REV.
D

AS1895™/5

RATIONALE

FLANGE, MALE, SEAM WELD
TYPE II LOW PROFILE

FIGURE 1 - TYPICAL SECTION

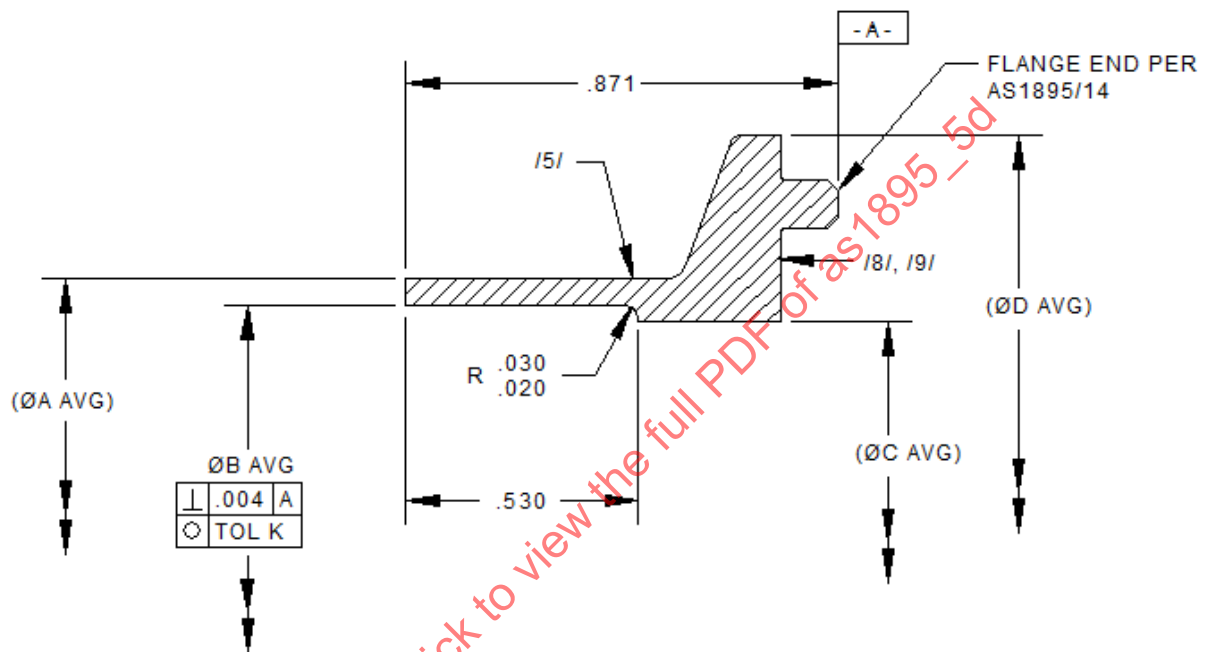
GRAPHICS REDRAWN. CIRCULARITY REQUIREMENT REMOVED FROM ØA. ØA CHANGED TO A REFERENCE DIMENSION. TABLE 1 REDRAWN TO ADD 'REF' TO DIM A, C AND D. NOTE 3 REVISED TO STATE CURRENT QML NOTE. GENERAL UPDATING OF SPECIFICATIONS BEING SPECIFIED HEREIN. CHANGE BAR NOTE REVISED. NOTE 17 ADDED.
